Subject: Duke Energy Carolinas, LLC ("Duke Energy" or "Duke")
McGuire Nuclear Station, Units 1 and 2; Docket Nos. 50-369, 50-370
Catawba Nuclear Station, Units 1 and 2; Docket Nos. 50-413 and 50-414
License Amendment Request for Methodology Report DPC-NE-3001-P, Revision
1, *Multidimensional Reactor Transients and Safety Analysis Physics Parameters
Methodology* (Proprietary)
Response to NRC Request for Additional Information (RAI)
(TAC Nos. MF3119, MF3120, MF3121, and MF3122)

Attachment B
Duke Non-Proprietary Responses to NRC Request for Additional
Information for Revision 1 to DPC-NE-3001-P

Revised Figure 6-10
Dropped Rod Accident Analysis Flow Diagram

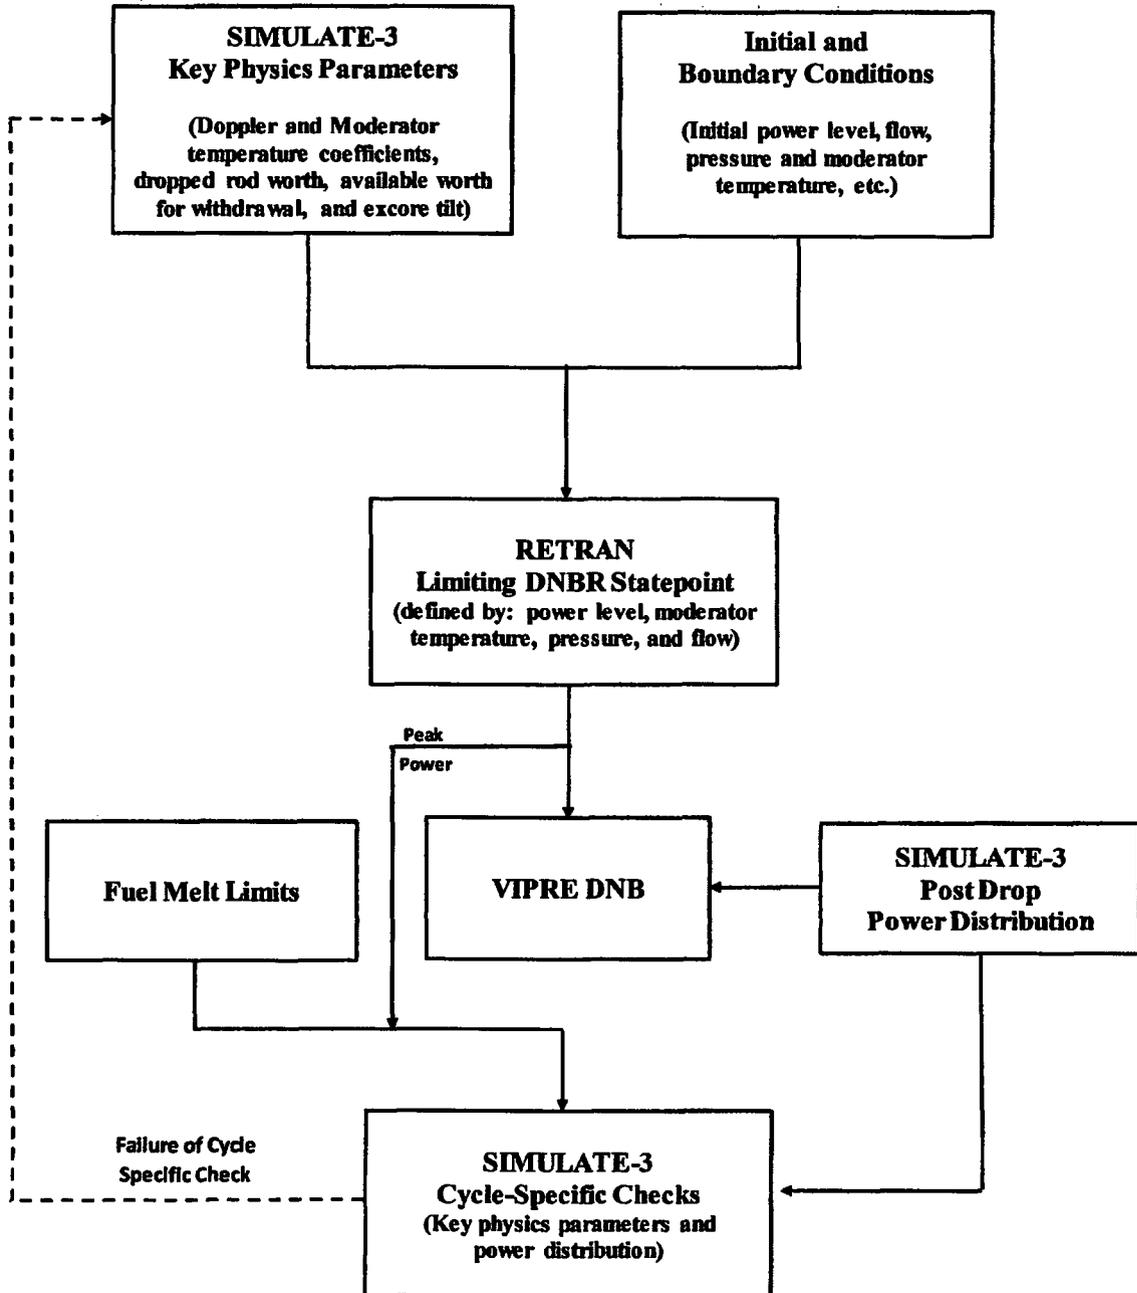
15. In Figure 6-10, which is a flowchart of the dropped rod accident analysis, the box labeled “Fuel Melt Limits” is not connected to any other boxes. How do the fuel melt limits factor in to the analysis?

A revised Figure 6-10 is provided. For each dropped rod combination, the post drop three-dimensional Fq power distribution is calculated and compared against fuel melt limits calculated to by an NRC-approved fuel performance code to confirm margin exists to these limits. The predicted Fq power distribution is increased by uncertainty factors that account for [

] If a centerline fuel melt limit is exceeded, either the dropped rod transient analysis is evaluated, re-analyzed or the core is redesigned to obtain acceptable peaking factors.
